CAMPAIGN 5707 - Service Campaign
Model: Fiat Ducato "recreational" version
- rear fog light wiring

CAMPAIGN

5707

COMPONENT:	Rear fog light power supply wiring		
FAULT:	Layout not correct		
VERSION:	Ducato, with cab and chassis/with chassis cowl models		
CONCERNED VEHICLES:	All vehicles with chassis numbers listed in SIGI. (Chassis ranging between 2299074 and 2348976) Vehicles assigned to you: consult your PC for the chassis numbers involved in the campaign.		
TECHNICAL CAUSE:	Production process		
RELEASE NO.:	0		
MATERIAL:	Description:	Part No.:	Q.ty:
	Rear fog light wiring	1375878080	01
	Cable ties	14560187	10
SPECIAL TOOLS:	-		
EPLUS ORDER UPLOADING METHOD:	-		
REMUNERATION:	Cost:	Campaign:	Operation:
MANPOWER AND MATERIAL:	A01	5707	A
MISCELLANEOUS (MAIL, ETC.):	A10	5707	-
SOLUTION IN PRODUCTION:	The assembly of complying vehicles is guaranteed		
NETWORK INTERVENTION IDENTIFICATION:	A spot of white paint on fuse box		
	Therefore, it is compulsory to make a pre-delivery intervention to final customers, to upgrade all vehicles.

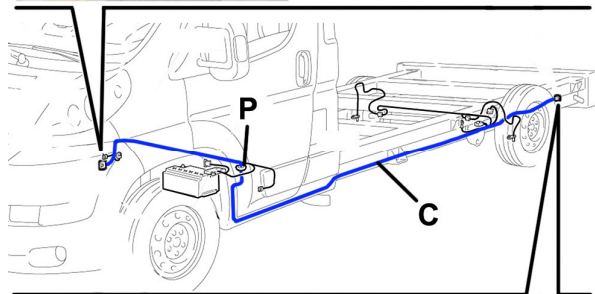
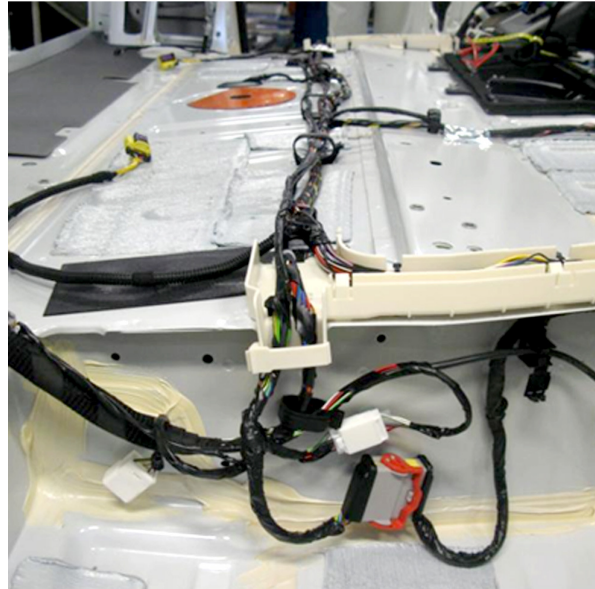
- Disconnect the negative battery terminal.
 - Remove the compartment floor mat, as shown, with reference to Op. 7040L10 of the Service Manual, to reach the left longitudinal wiring.
 - Take the new supply harness for rear fog lights from the Spare Parts Dpt. (see Part&Service availability).
 - Working in the right kick plate area, disconnect the electrical connection D221.
- With reference to Op. 5590E of the Service Manual:
- Fit the terminal of the new harness in the block, pin 4 cavity, as shown.
 - Fit the block in the shell and suitably protect the connection using insulating tape.
 - Make the harness (C) (marked in blue in the picture) pass through the duct seal (P), following the path of the left longitudinal harness (re. 23 on the Service Manual).

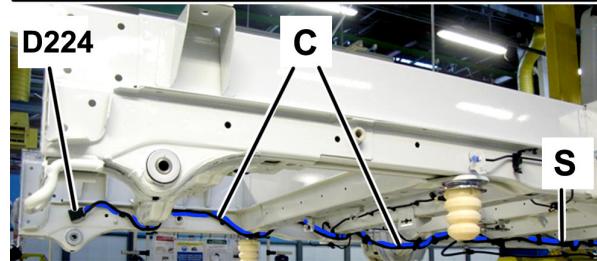
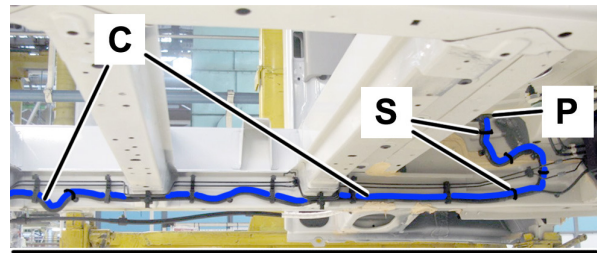
- Make the harness (C) (marked in blue in the picture) pass following the path of the longitudinal left wiring, until reaching connection D224.

- Take out the protection plug from the pin 10 cavity of the connector block, then fit the terminal of the new harness.
- Suitably protect the connection with insulating tape.

- Secure the new harness (C) to the available clips and, where they are missing, fasten using some ties (S) (see Part&Service availability).

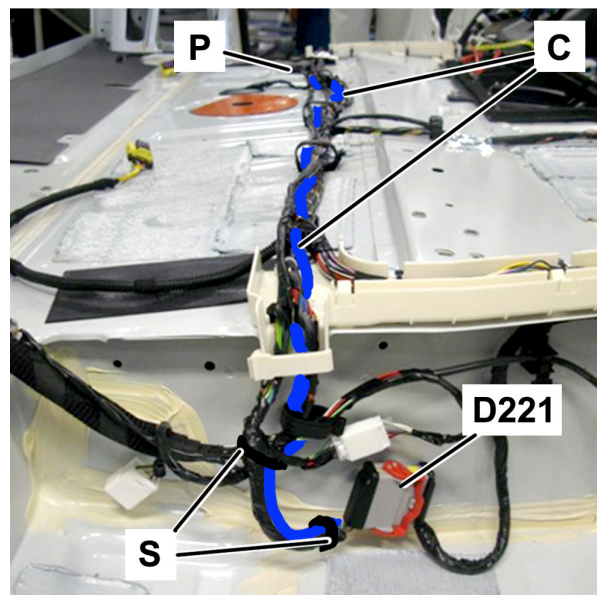
- Secure the new harness (C) to the available clips and, where they are missing, fasten using some ties (S) (see Part&Service availability).
- Refit the compartment floor mat, with reference to Op. 7040L10 of the Service Manual.
- Connect the negative battery terminal.
